**LONG BEACH CITY COLLEGE DISTRICT
CONTRACTS MANAGEMENT DEPARTMENT**

**BID C2194A ADA SITE BARRIER REMOVAL PROJECT
AT THE
LIBERAL ARTS CAMPUS**

ADDENDUM NO # 1

OCTOBER 19, 2020

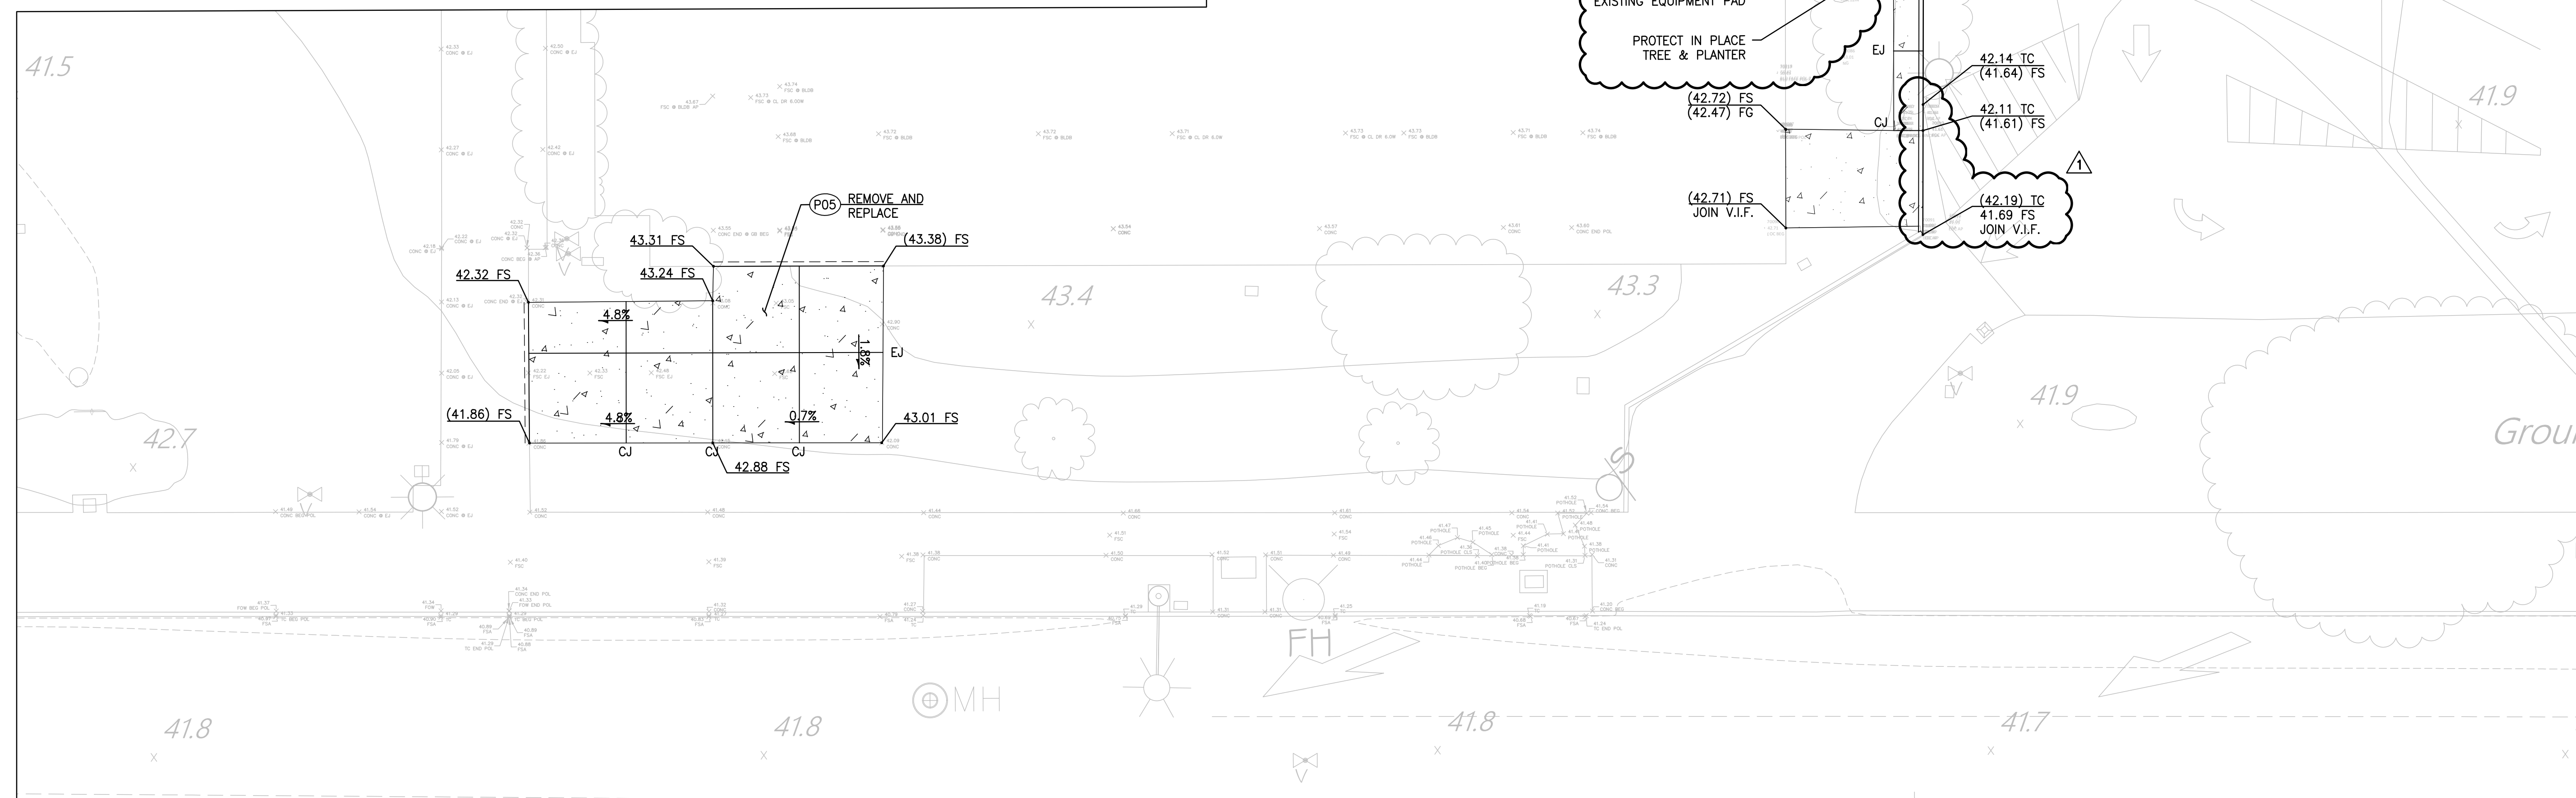
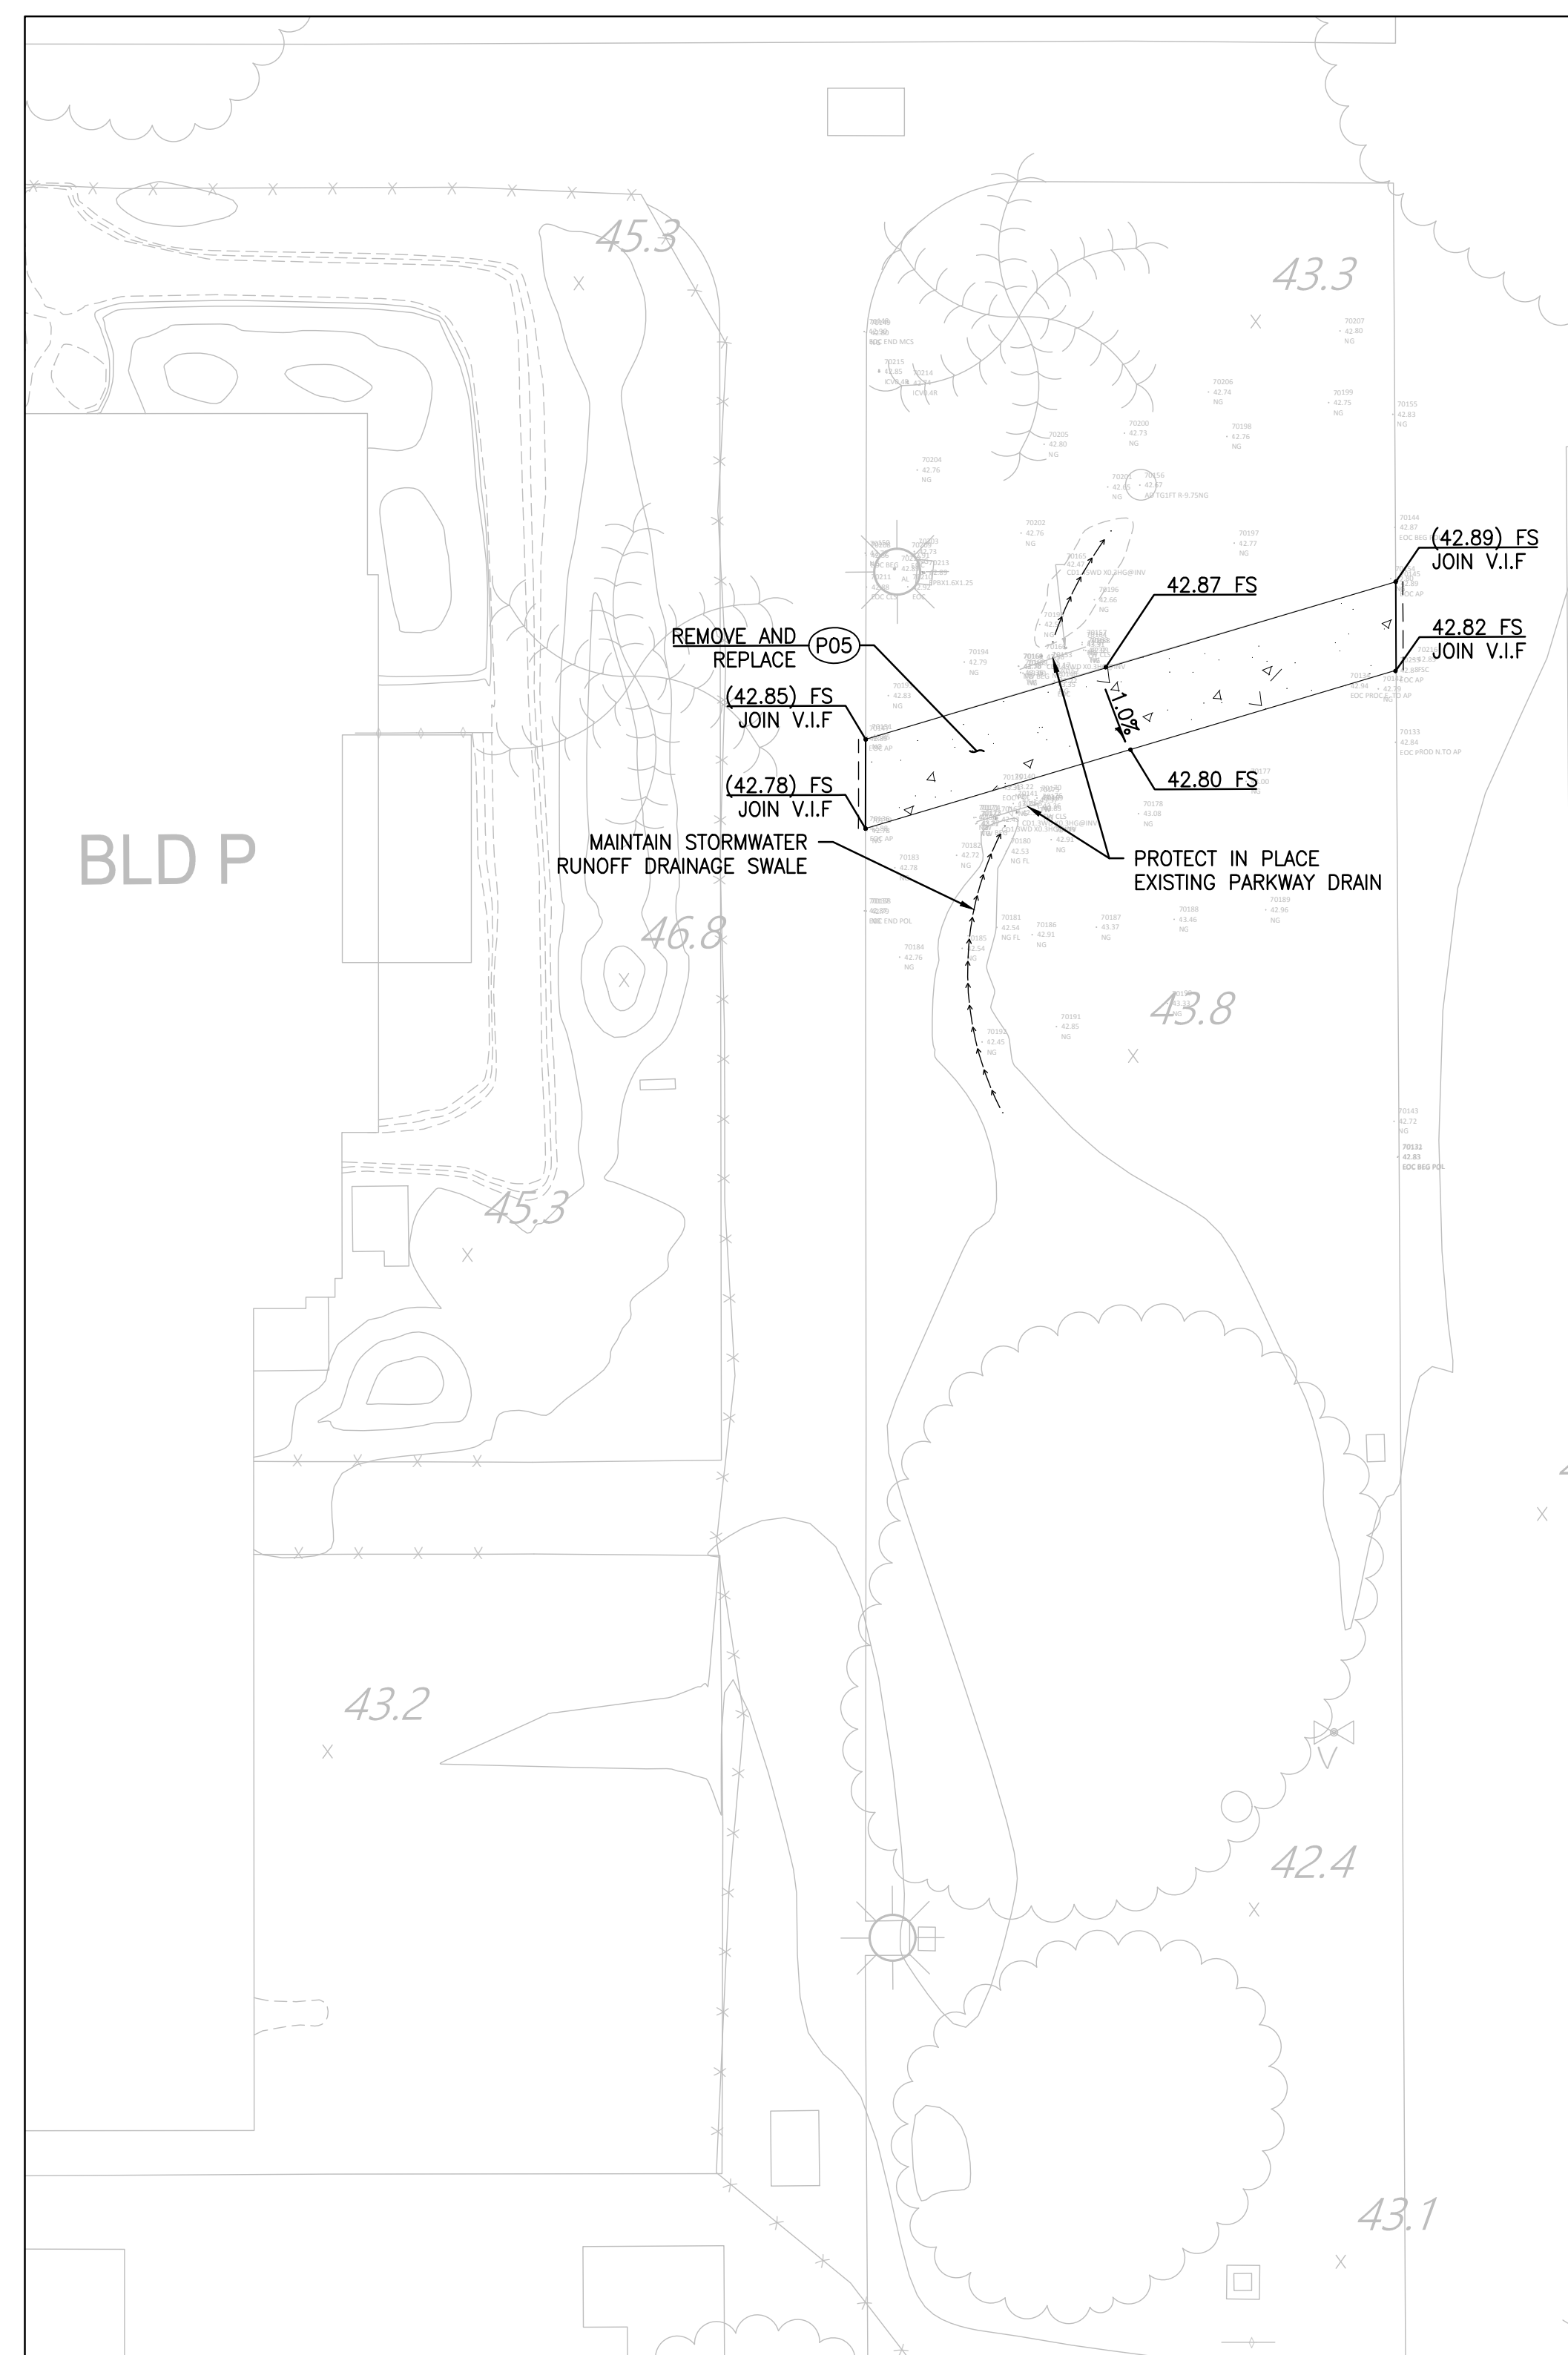
3. Q: C1.16 - In front of Building D and Building E, there are several light post in the planter area. What happens with these light poles? Will be put a curb around them?

A: Curb to be installed around a light pole base. Provide curb drain at depressed light pole base area. See Addendum 1 Sheet C1.16.
